Monterey Bay Aquarium Research Institute
7700 Sandholdt Road
Moss Landing, CA 95039
(831) 775-1700
www.mbari.org

Title Schematic, Lower Half Elex, Coastal Float, P1 version		Document Number 100221252	Rev B
Variant <variant>			
Size B	Date: Wednesday, May 09, 2018	Engineer Massion/Mellinger	Sheet 1 of 1
Design File X:\CPFI\ELECTRICAL ENGR\IORDCAD PROJECTS\IEDS STUFF\LOWER HALF ELEX P1\SCHEMATICS\100221223 CPF LOWER H			
Schematic Name SCHEMATIC1		Page Name PAGE1	Layout File <Layout File>

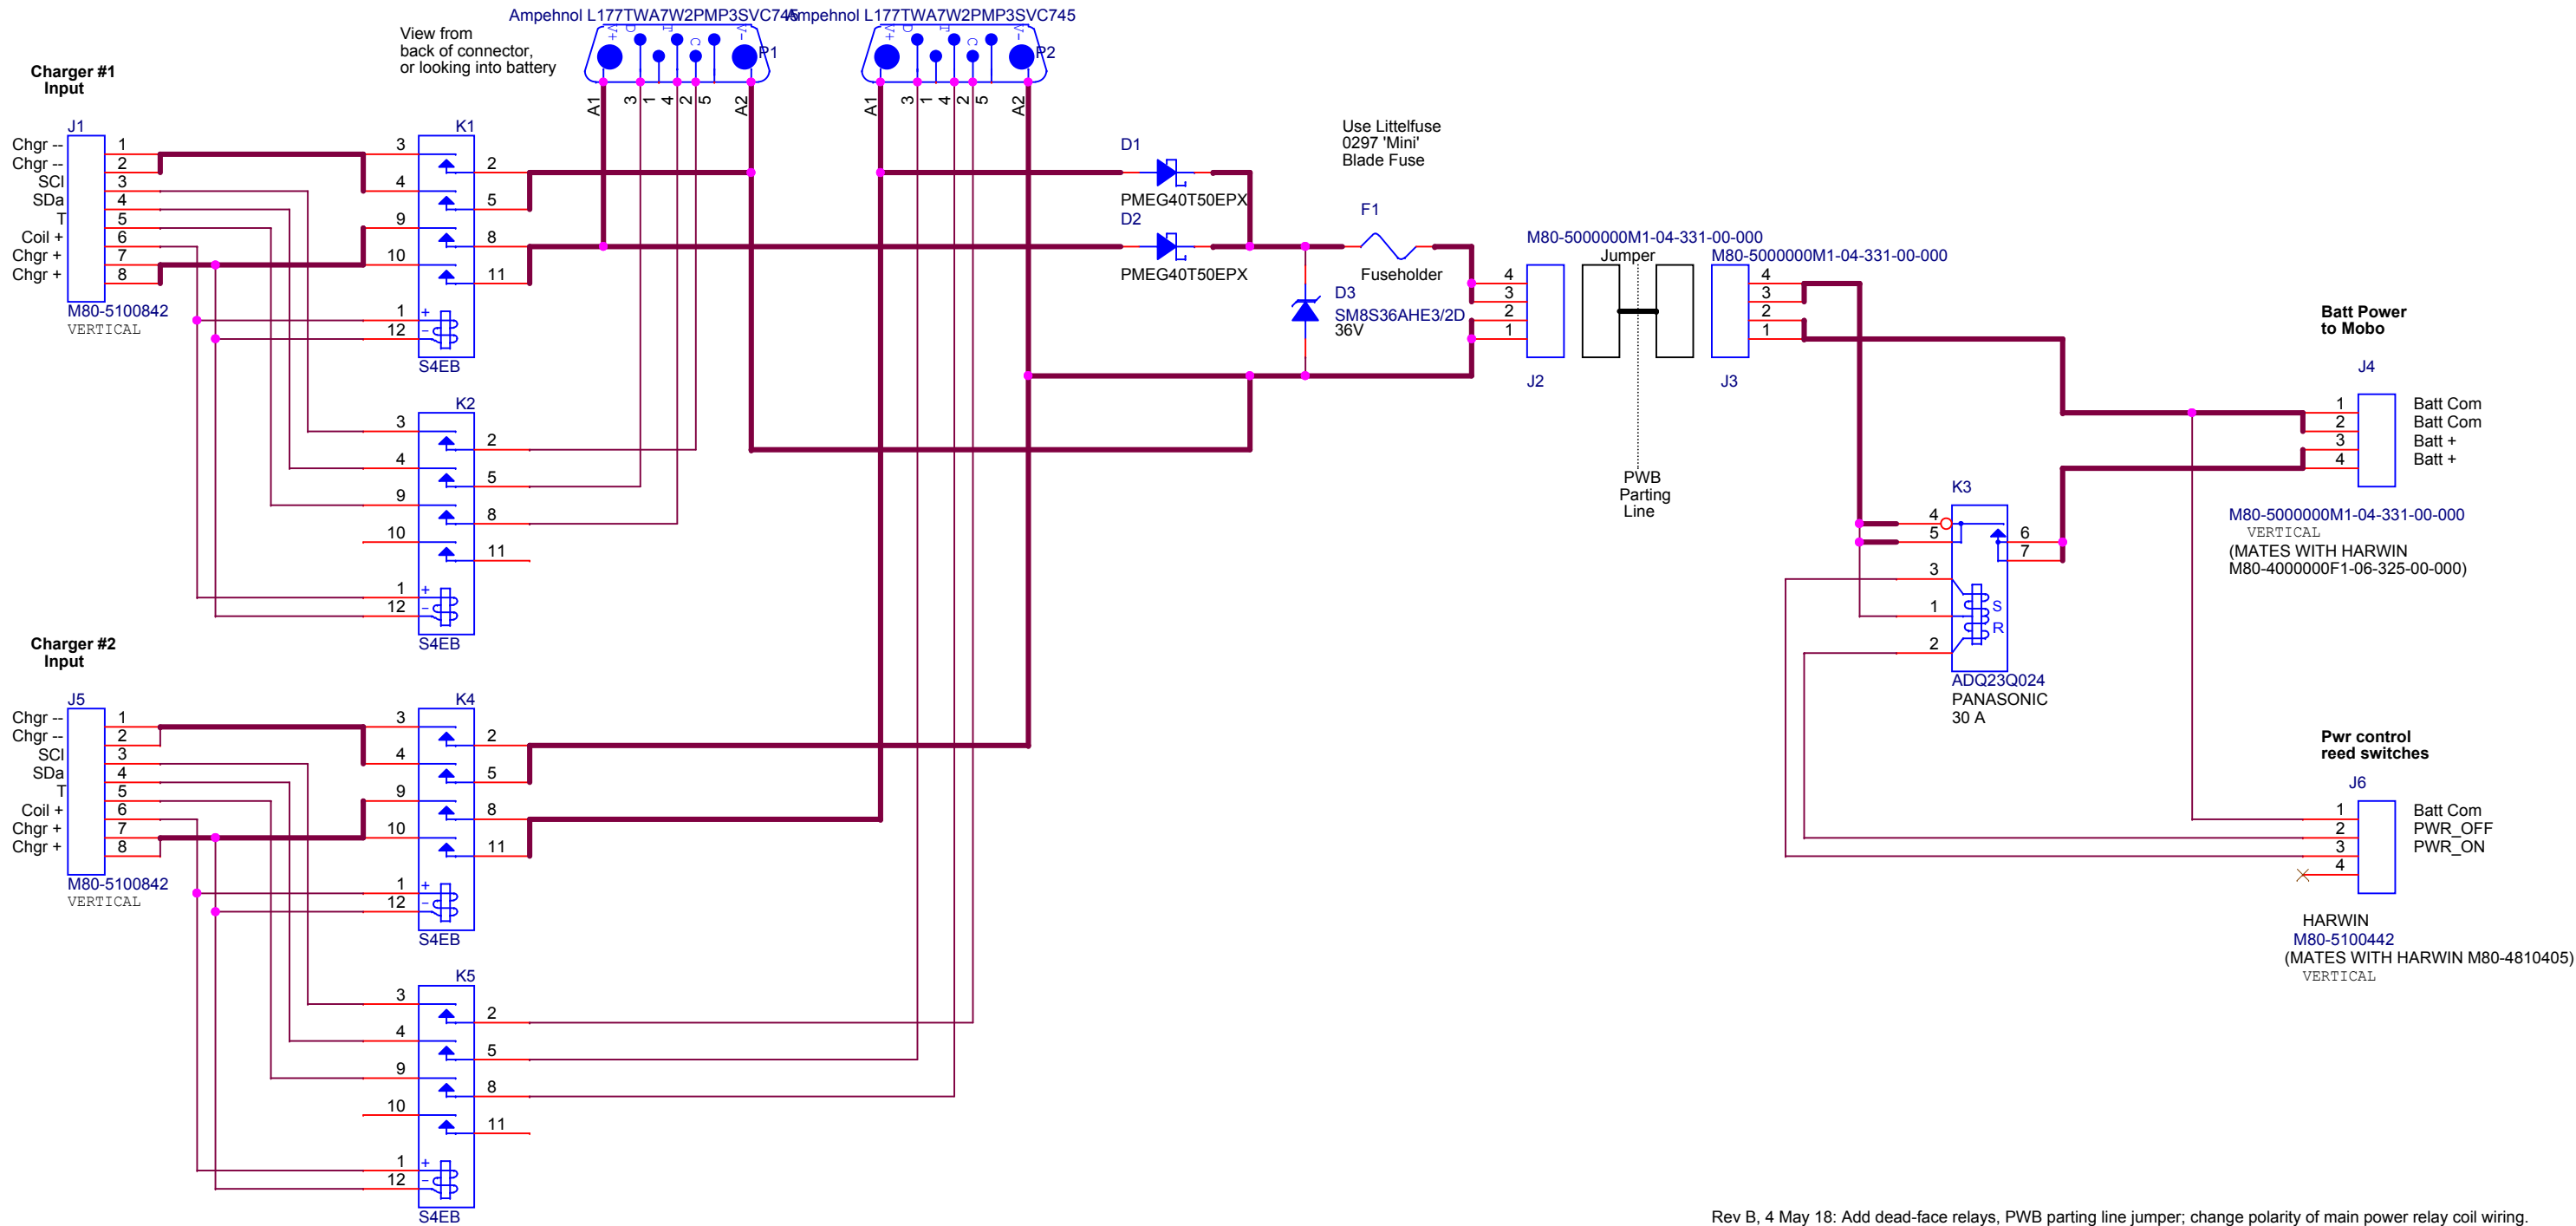
Rev B, 4 May 18: Add dead-face relays, PWB parting line jumper; change polarity of main power relay coil wiring.
Rev A, 20 Apr 18: Move reed switch 28V feed to battery side of relay.
